PowerXL
RAM05/RASP5 Firmware
Firmware Release Note

- 1 V1.04 RAM05 Change Notification - 15.07.20204
- 2 V1.04 RASP5 Change Notification - 15.07.20205
- 3 V1.05 RAM05 Change Notification - 22.10.20218
- 5 V1.05 RASP5 Change Notification - 22.10.20219
- 6 V1.06 RAM05 Change Notification - 01.05.2023 11
- 7 V1.06 RASP5 Change Notification - 01.05.2023 12
- 8 V1.07 RASP5 Change Notification - 12.05.2023 13

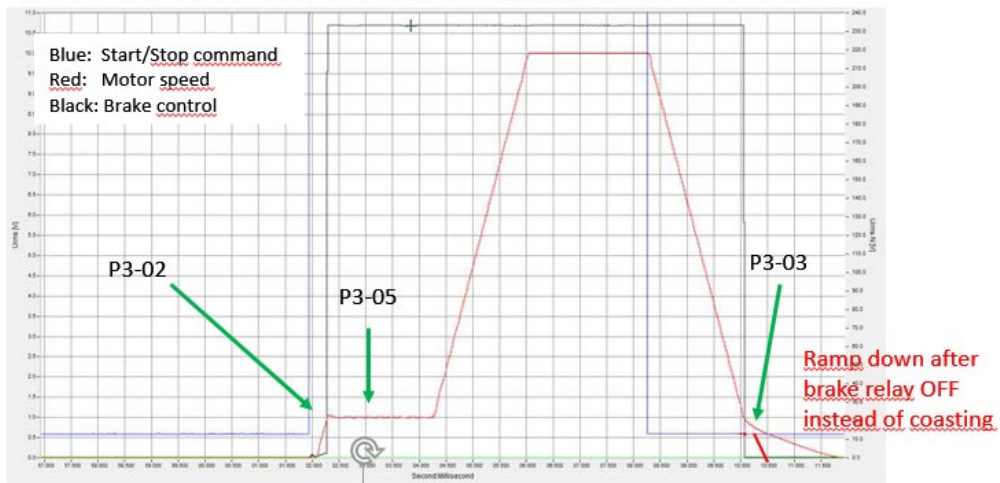
4. Default parameter value changes

New default value has been given to the following parameters

P6-02 = 100%

P6-03 = 0.025s

P6-15 = 2.5%

P6-17 = 0

6. Added New Advanced Mode 2 Brake Control Option (P3-01 = 2)

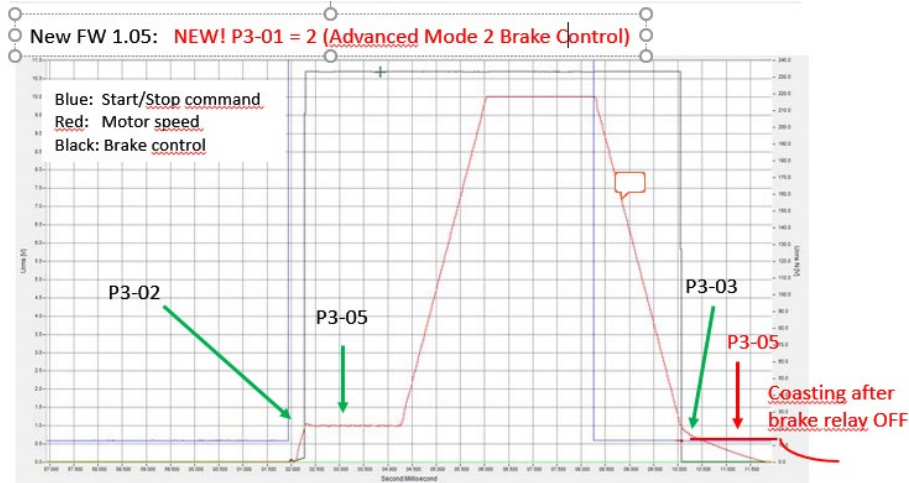
A new option has been added to P3-01 for advanced brake control (P3-01=2).

After receiving a STOP! command, drive will ramp down to Brake Apply Speed (P3-03) and remain at this speed for the time specified on P3-05 waiting for the motor brake to be applied. After this time has expired, drive will coast to stop (C2S).
